Please accept this letter as a request to amend mb microtec's SSD #NR-0446-D-103.

mb microtec is rebranding its GTLS's (gaseous tritium light sources) from mb microtec to trivalight®. While mb microtec ag will continue to be the manufacturer and manufacture the GTLS's in the same location in Neiderwangen, Switzerland, we would like to request an amendment to the aforementioned SSD, to remove "mb-microtec" from the watch backs and replace the text with "trivalight®".

mb microtec SSD amendment request.

Examples of engravings to watch backs:

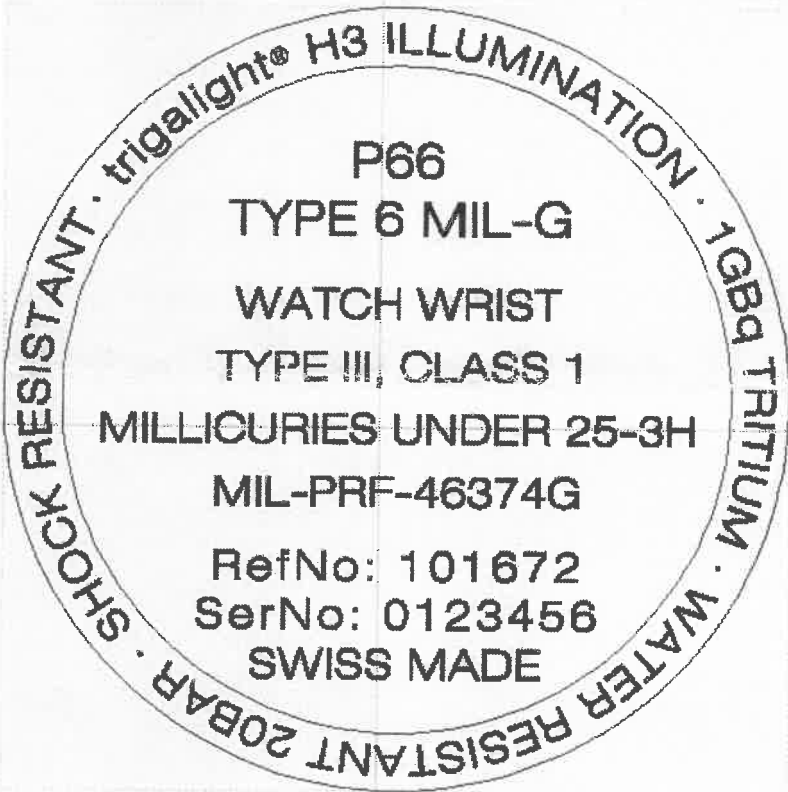
Examples of watch backs with the new engraving are included with this request.
